CITY PLANNING COMMISSION

- A. Negative Declaration
- B. Tentative Map to divide 16.1+ acres into 81 standard single family lots to be called Mesa Grande Unit 8 in the Standard Single Family (R-1) zone

TENTATIVE SUBDIVISION MAP
MESA GRANDE UNIT NO. 8
 City of Sacramento, California

P-89-093

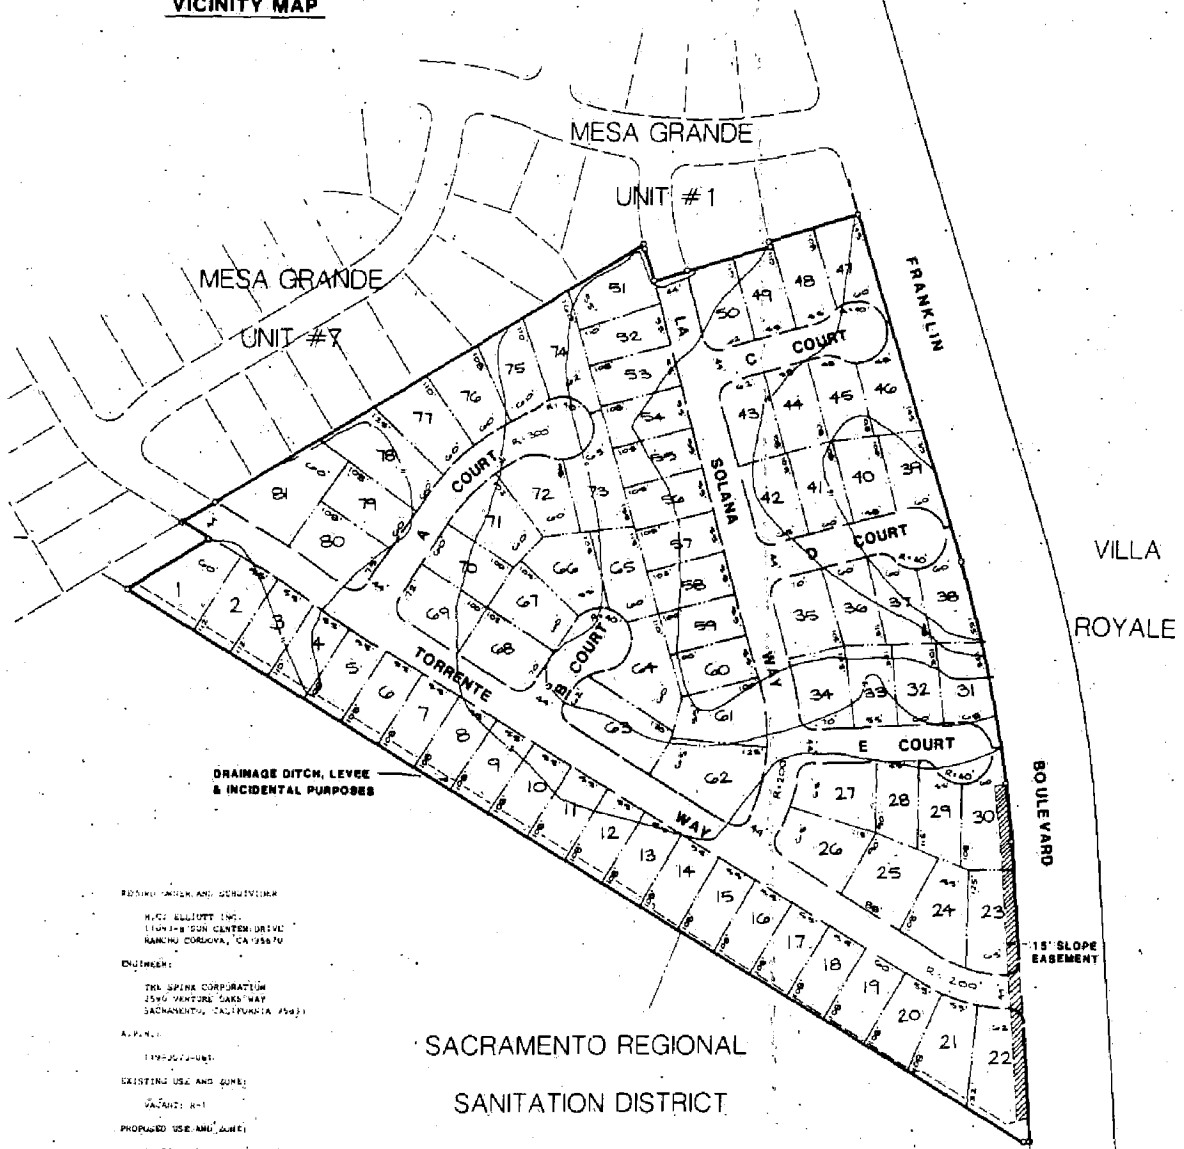
The applicant proposes an 81 unit standard single family subdivision in the R-1 Zone. All proposed lots meet the minimum dimensions and lot area requirements in the R-1 Zone. No floor plans or elevations for the dwellings were submitted with the tentative map request. A 15 foot wide slope easement is proposed along lots 22, 23, and 30 for the ramp up to the bridge over Union House Creek. Access to Franklin

Boulevard from Torrente Way may require relocation to the satisfaction of the City Traffic Engineer due to its proximity to Union House Creek or plans for the median along Franklin Boulevard.

Staff and the Subdivision Review Committee have reviewed the proposed design and support the proposed lot layout. The further study of right-of-way for Union House Creek is required by the Public Works Department. The results of the study may require redesign of lots adjacent to Union House Creek.

12. Construct improvements on Franklin Boulevard as per plans on file with the City Public Works Department;
13. Torrente Way to be dedicated to a 50 foot right-of-way between Franklin Boulevard and Solana Way. (Note: Franklin Boulevard will have a center median without a break at Torrente Way.);

15. Right-of-Way Study required for Franklin Boulevard (120 ft R/W);
16. Applicant shall coordinate Franklin Boulevard improvement with Public Works Department - Engineering Division; Median improvements are currently under design;

17. Annex to Regional Sanitation District and pay necessary fees;
18. Right-of-Way study required for Union House Creek. Additional easement dedication may be required to the satisfaction of the Public Works Department Flood Control Division;
